VEHICLE RECALL

IC CORPORATION RECALL # 02301
NHTSA RECALL # 02V-173

SUBJECT: **VEHICLE RECALL**
Between the Rail Fuel Tank System Crossmember

CORRECT CROSSMEMBER IS THE TOP ONE

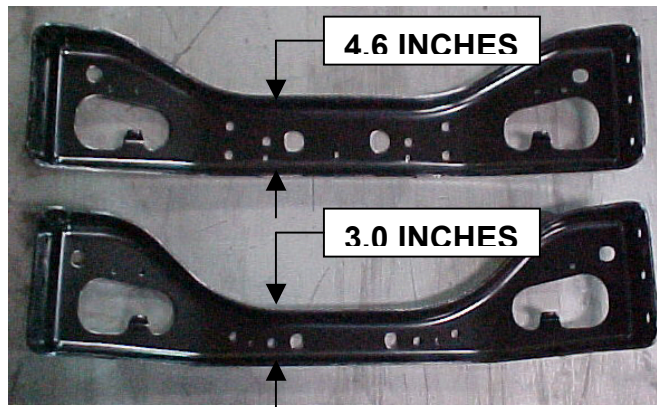
On some of the subject IC buses, the crossmember located just in front of the fuel tank may be incorrect. The correct crossmember is of heavy-duty design and the certification of the system was based on the heavy-duty crossmember.

- The upper crossmember in the picture shows the correct crossmember with a center height of approximately 4.6 inches.
- The lower crossmember in the picture is the wrong one with the center height of approximately 3 inches.

The owner or dealer may perform this repair. The repair procedure involves replacing the crossmember located just in front of the fuel tank. Complete instructions are included with the kit. No special tools are required.
